Technical Service Bulletin: TSB101121

QST30 Only Runs on One Bank and Fault Code 166 is Active.

Figure 1: Resistor Location for QST30 Industrial Left Bank

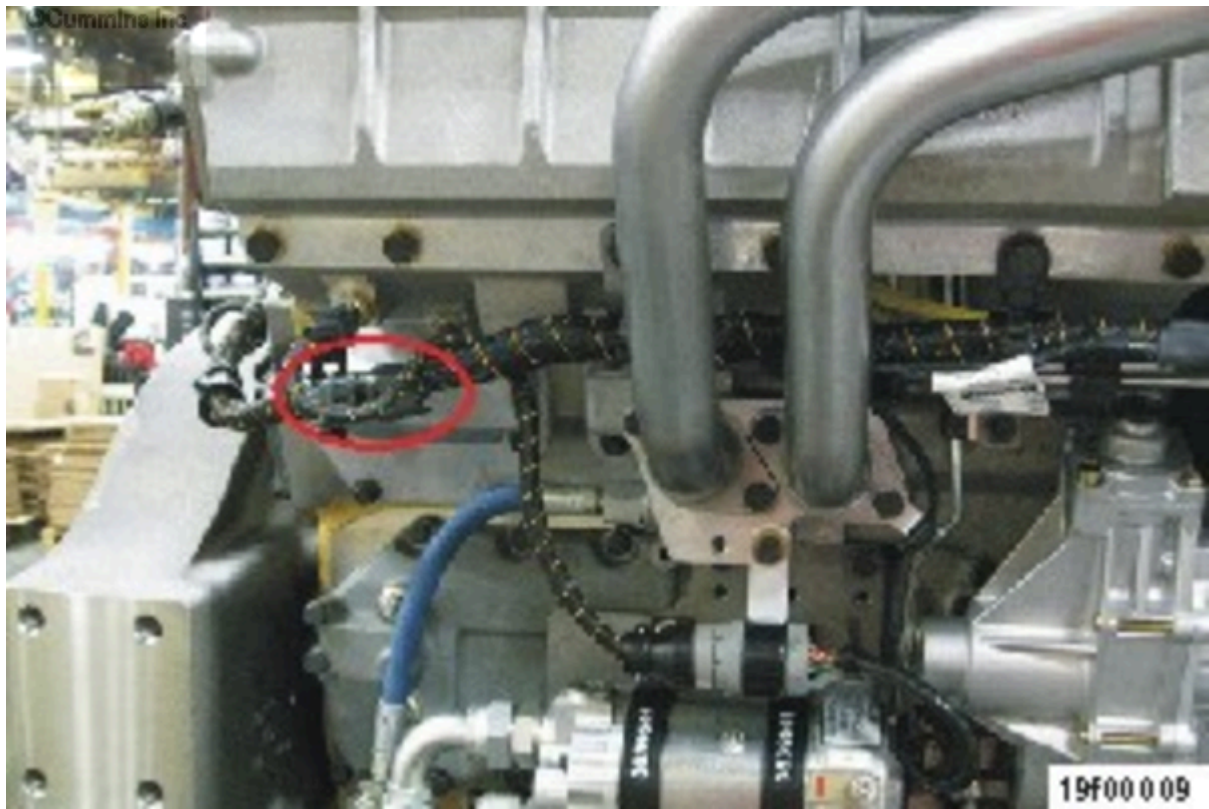
A resistor has been added to the left bank engine wiring harness to prevent Fault Code 166 from becoming active and the engine from running on one bank if a voltage spike from the CM552 ECM occurs.

Check to see if there is a resistor installed between the rack position common wire and ground on the bank that is **not** firing. See the attached figures for resistor locations. If a resistor is **not** found, install a resistor in the wiring harness or replace the wiring harness. Refer to the wiring diagram for the pin location identification. If a resistor is found, check the resistance.
